**POCATELLO/CHUBBUCK
SCHOOL DISTRICT NO. 25
Bannock County, Idaho**

Addendum No. 1

RE: Invitation to Bid, Carpet and Cove Base for Various District Buildings
School District No. 25
Pocatello, Idaho 83201

ELLIS ELEMENTARY SCHOOL
 CARPET REPLACEMENT FY 2018
 (Approximately) 21,271 SQ FT

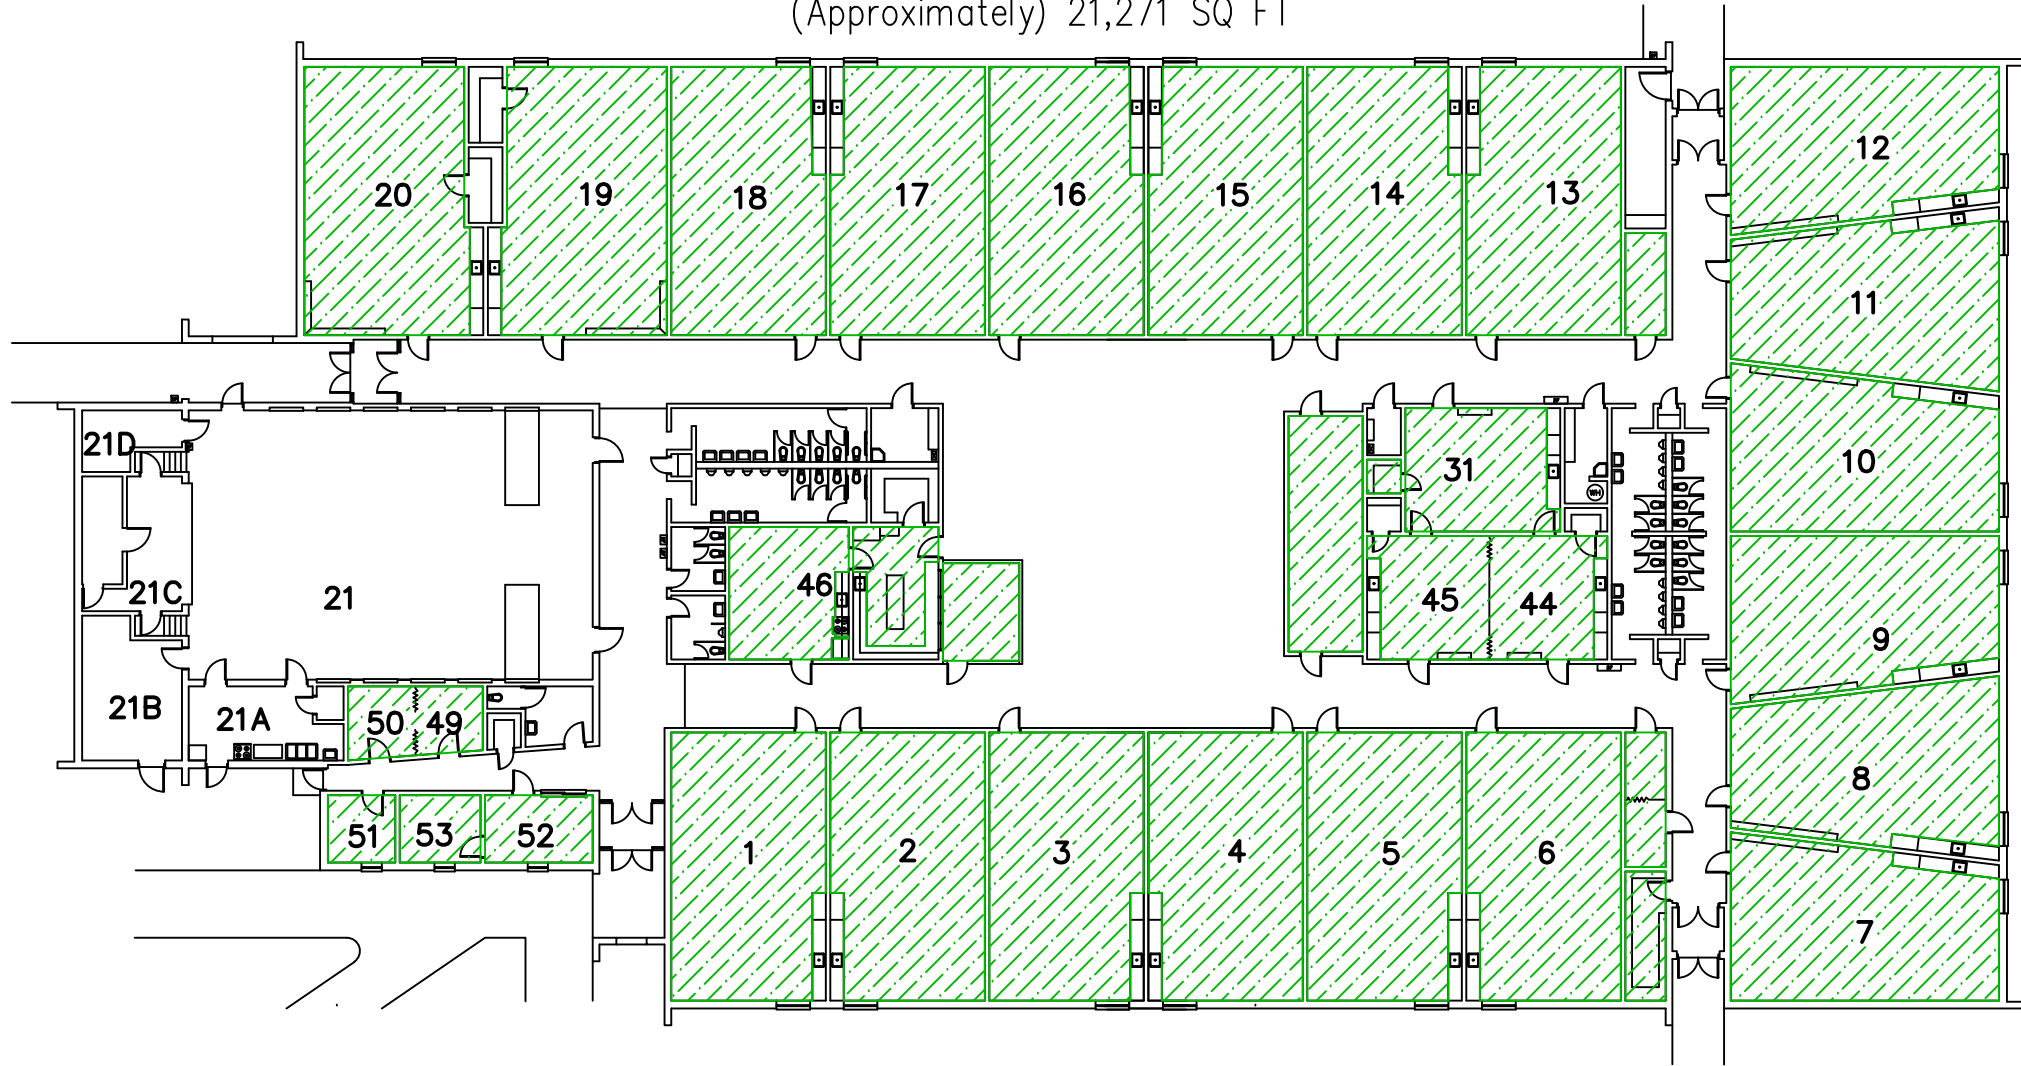
Change: Project 1 - Ellis Elementary: Add to the scope of work the additional square footage, Room #46 not shown on the original drawing. The cost of the additional square footage of materials is to be included in the bid response. ± 20,388 sf
